Docket Item #8
BAR CASE# 2005-00109

BAR Meeting
May 25, 2005

ISSUE: Alterations and addition
APPLICANT: Chris & Jennifer Patton
LOCATION: 414 North Fayette Street
ZONE: RB/Residential

Figure 2 Proposed north elevation

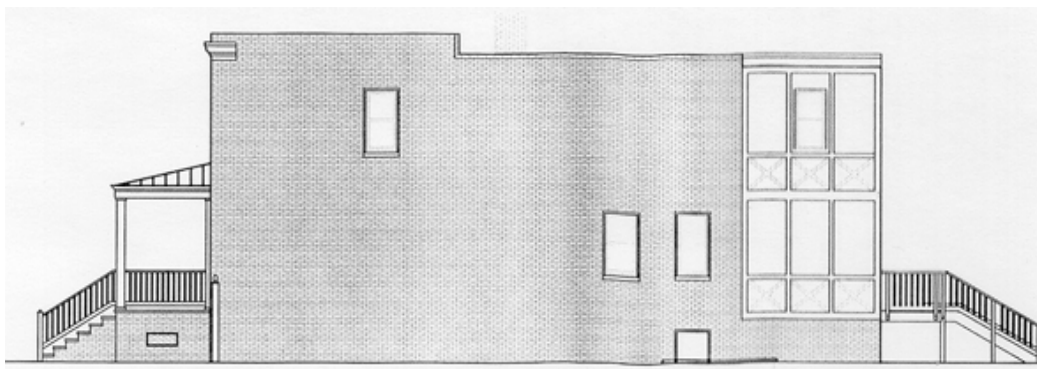
The existing one story enclosed frame porch has a sloping roof, vinyl siding on the north side elevation and a sliding glass door with metal railing on the rear (west) elevation. The existing frame porch will be extended upward to two stories and will have a flat roof. The current first story and new second story will be clad in exterior grade plywood panels. Wood trim pieces will define the two floors and separate the elevations into bays. The north side elevation will have three bays. The lower third of each bay will have an "X" pattern in trim.

Figure 3 West elevation

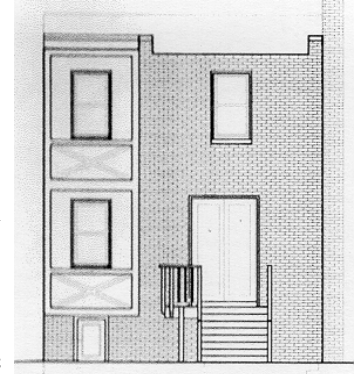
The rear (west) elevation will have a single bay on first and second story with an “X” pattern. The north elevation will have a single one-over-one window in the center bay of the second story. The rear elevation will have a one-over-one window in the first and second stories. The existing kitchen door will be changed from one fully glazed door to a set of double doors. The existing rear wood deck will remain. All doors and windows will be wood. All wood panels, trim, windows and doors will be painted.
